Outlets on upstairs platform

Outlets in pit

Outlets in H- control room

Outlets in RFQ injector line

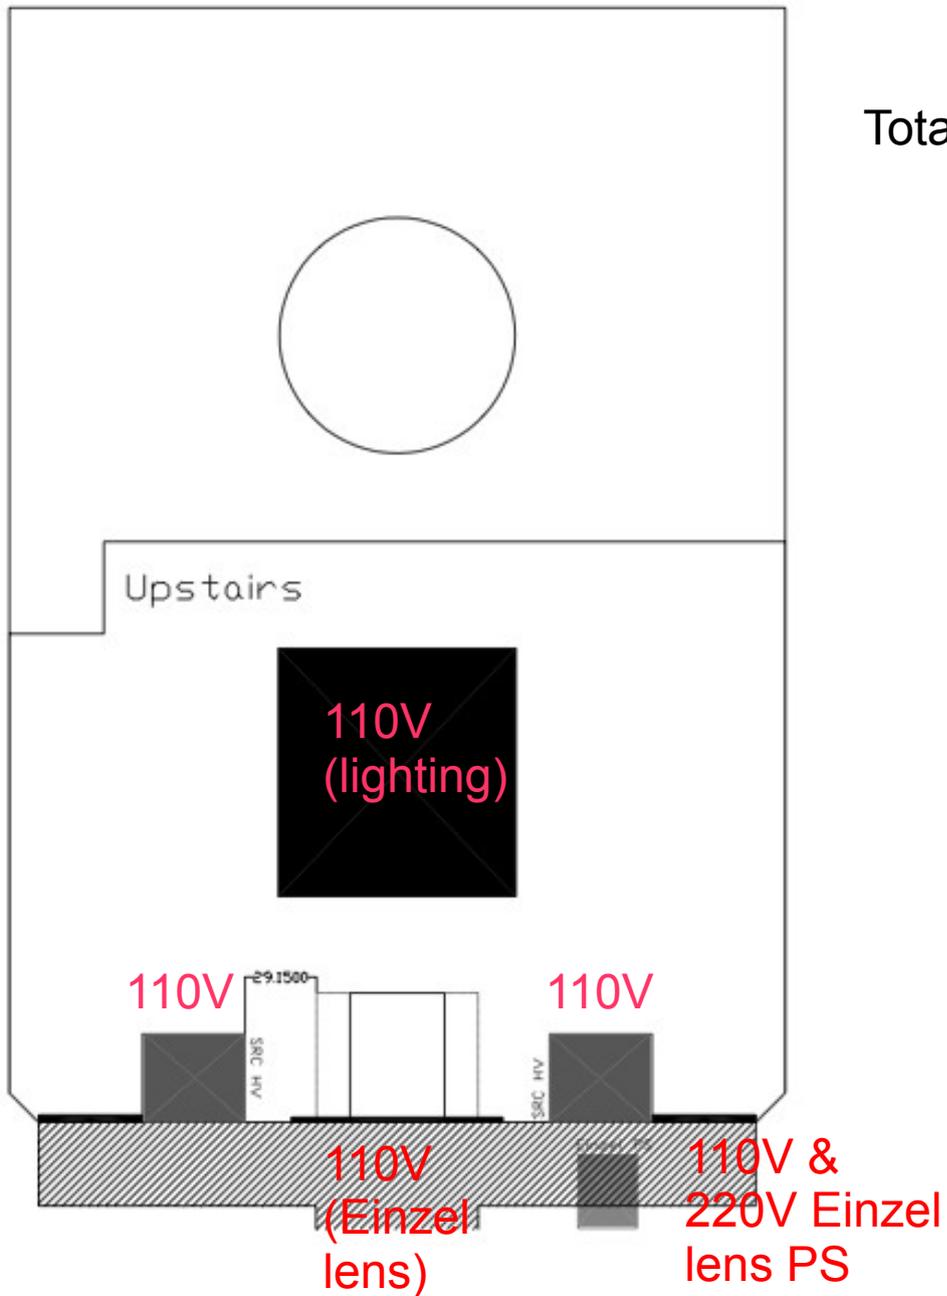
Total 110V = 4
220V = 1

More outlets for pit, see next slide for Steve Hay's more details.

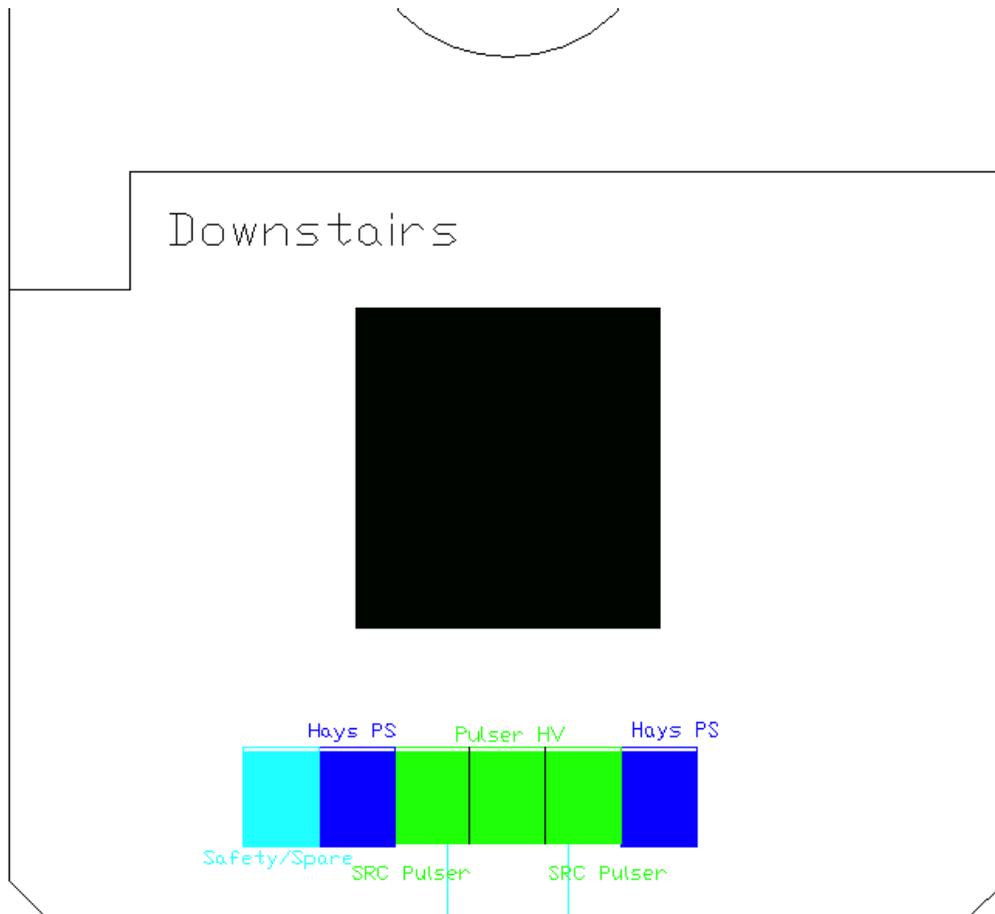
Where does safety relay rack go?

Rack	Voltage type	Quantity	Comments
Solenoid	480V	3 outlets	
	120V (1 circuit)	2 plug strips

Rack	Voltage type	Quantity	Comments
Quad	480V	4	
	120V (1 circuit)	2 plug strips

Rack	Voltage type	Quantity	Comments
Source HV	120V @ 20A (2 circuits)	2 plug strips	Can Steve and Dan share?
	220V	2	For extractor HV
(Steve hays)	208V	2	3 phase with disconnect
(Steve Hays)	120V	1 plug strip

Rack	Voltage type	Quantity
Source pulser (A)	120V	1

Rack	Voltage type	Quantity
Source pulser (B)	120V	1

Rack	Voltage type	Quantity
Spare/safety	120V	1

Additional: 1x 489V outlet with disconnect.

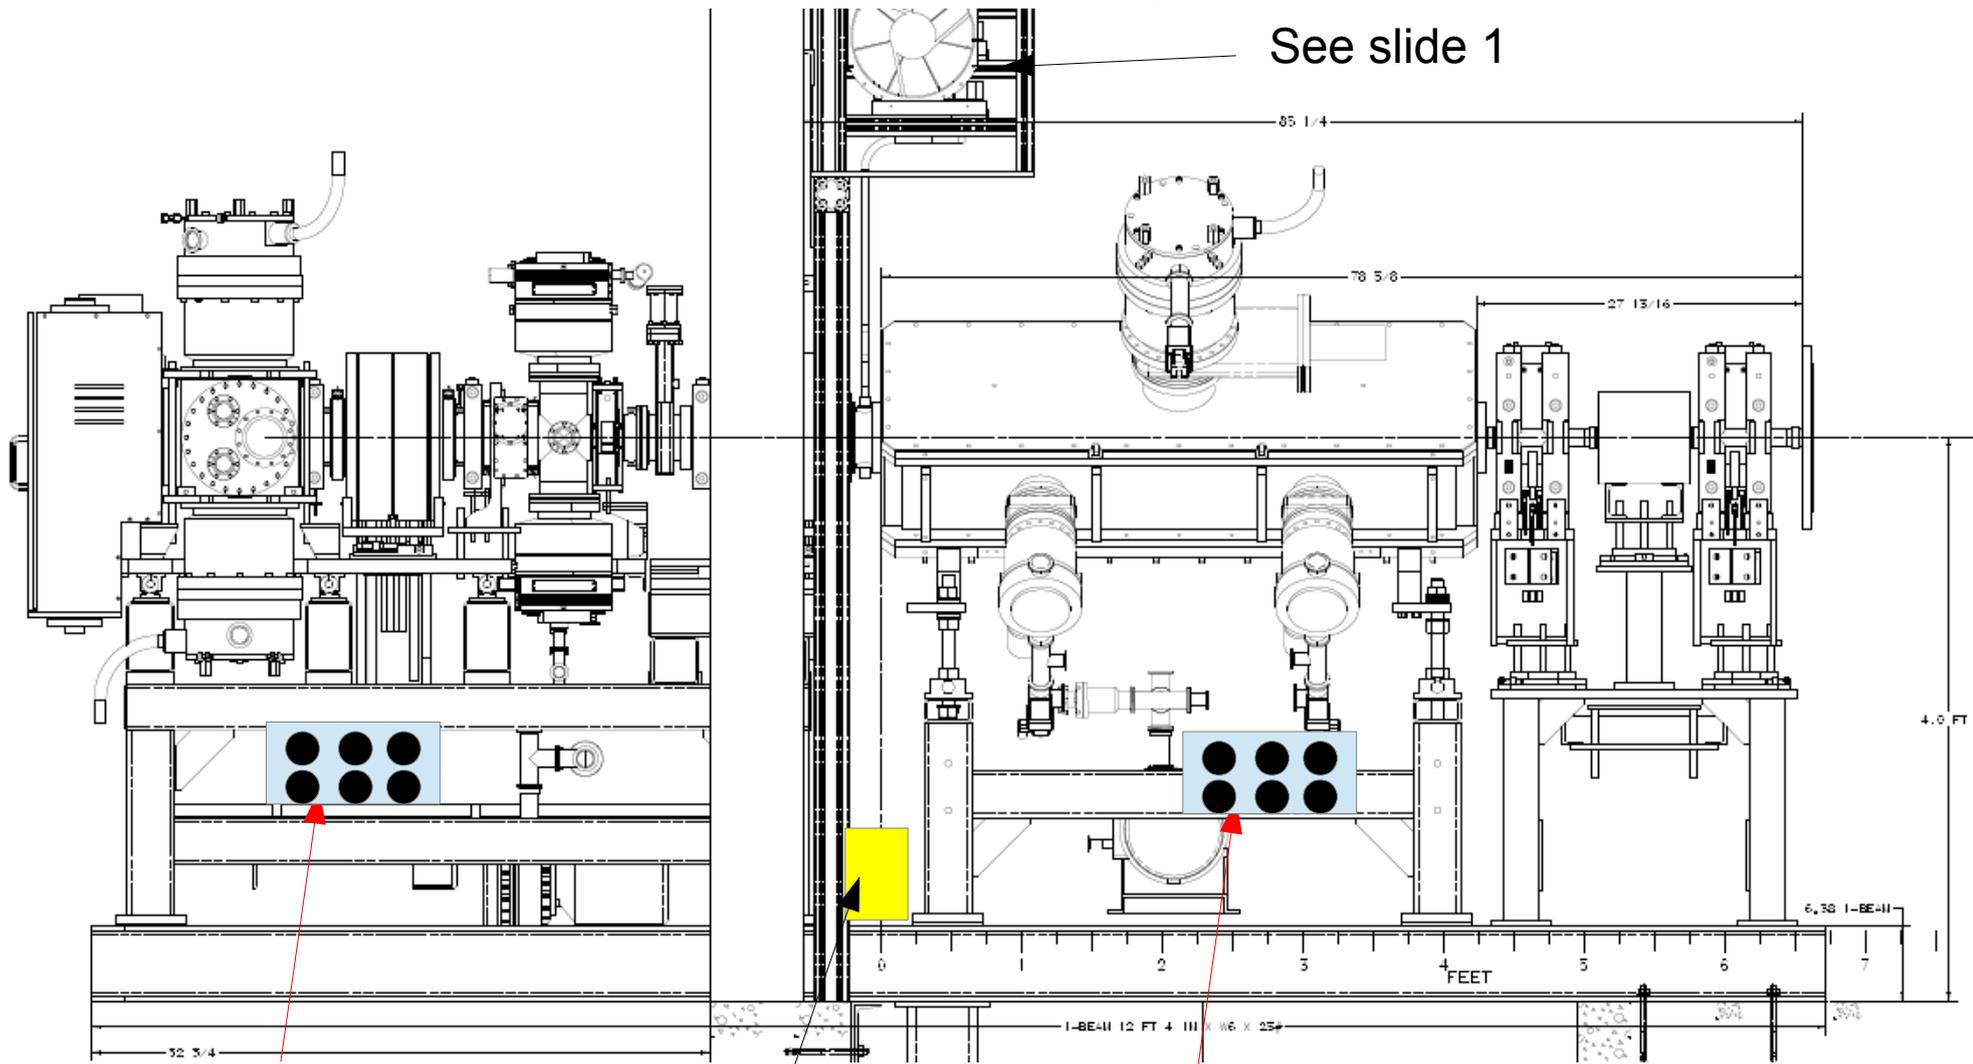
120V for fans

1x 208 3 phase with neutral,
5 wire 20A outlet .

120V for fans

Jeff will build 120V outlets
for the roughing pumps
tapping off from the 208
